Lahontan Regional Water Quality Control Board

**SUBJECT: PROSECUTION TEAM'S RESPONSE TO OCTOBER 16, 2015
PROPOSED CLEANUP AND ABATEMENT ORDER FOR PG&E TO
CLEANUP CHROMIUM CONTAMINATION FROM ITS HINKLEY
COMPRESSOR STATION, SAN BERNARDINO COUNTY**

November 3, 2015 Prosecution Team Comments on Proposed Cleanup and Abatement Order R6V-2015-Proposed and Attachment 8 - Monitoring and Reporting Program, released by Advisory Team on October 16, 2015

Attachment 1: Figure 5-3—Chromium Results for Lower Aquifer Groundwater

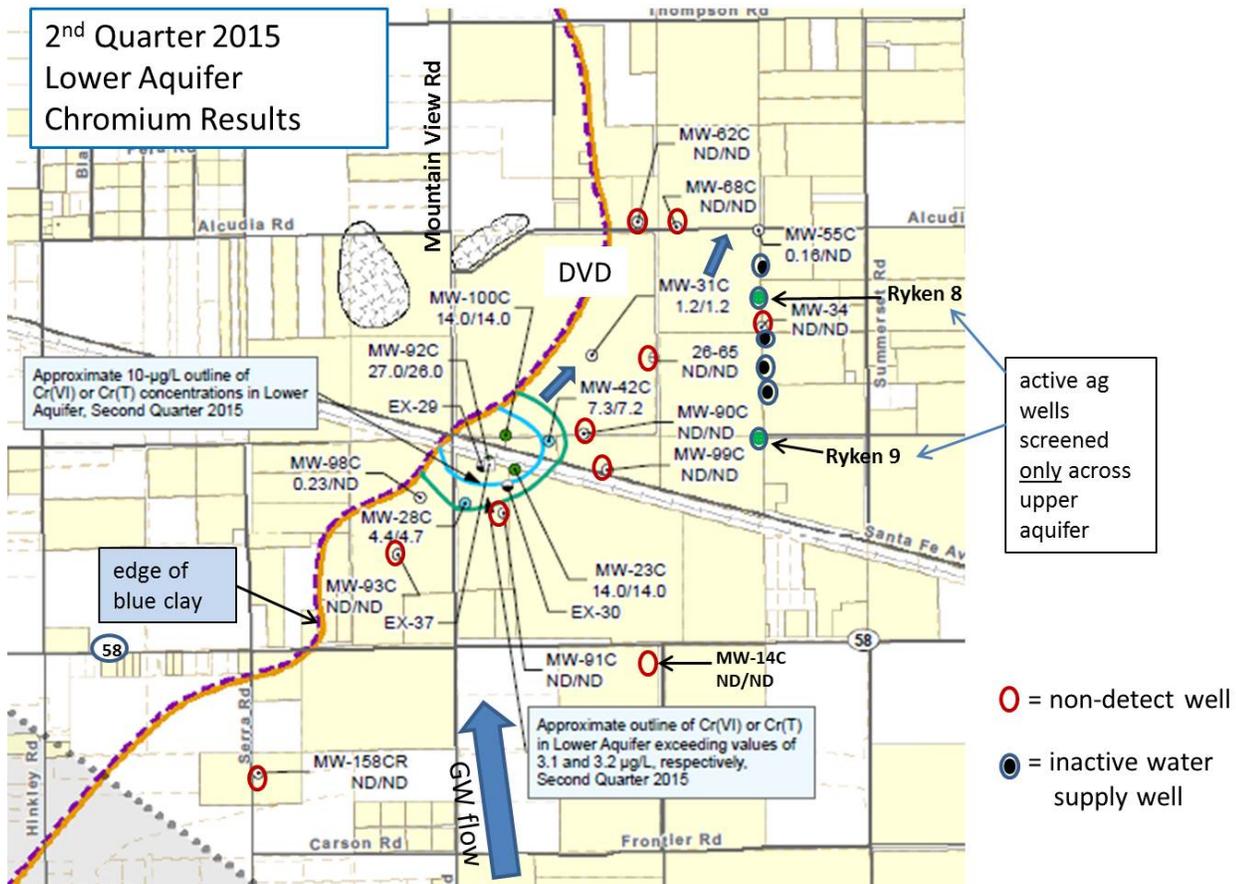
Evidence collected to date clearly supports background levels in the “localized area” of the lower aquifer are less than or equal to 0.2 parts per billion (ppb). The August 1, 2011 report submitted by PG&E concerning the lower aquifer investigation contained what amounted to a

site conceptual model. Figure 3 in the report (Attachment 1) shows a map where five monitoring wells (MW-23C, MW-28C, MW-42C, MW-92C, MW-100C) sufficiently define the extent of chromium out to 3.1 ppb Cr(VI) and 3.2 ppb Cr(T) in an area of less than one-half mile square. Subsequent monitoring reports submitted by PG&E since 2011 contain groundwater data indicating the lower aquifer background levels in the “localized area” are <0.2 ppb Cr(VI) and <1.0 ppb Cr(T). Four monitoring wells (MW-90C, MW-91C, MW-93C, MW-98C, and MW-99C) lie in the upgradient and cross gradient groundwater flow directions and within a quarter-mile of the drawn plume outline. Two upgradient monitoring wells (MW-91C and MW-93C) have shown non-detectable concentrations (to at least <0.2 ppb and <1.0 ppb) for Cr(VI) and Cr(T), respectively, since 2011. In addition, there is one more monitoring well (MW-98C) in the upgradient flow direction of the plume outline having 0.34 ppb Cr(VI) and non-detectable concentrations of Cr(T). This latter monitoring well is likely detecting chromium related to PG&E’s discharge since its location is both adjacent to the chromium plume outline and the western edge of the blue clay where chromium migration from the upper aquifer occurred. Thus, MW-98C is not considered a background monitoring well. The nine monitoring wells in the “localized area” [five within and four outside the chromium plume as seen in Figure 5-3 in the 2015 2nd Quarter Monitoring Report (Attachment 2)] comprise an area the size of less than a half-mile square.

There is no need to cause further delay by requiring an additional site conceptual model before setting cleanup background levels when we already have the needed data. The finding should be revised to remove the requirement for the site conceptual model.
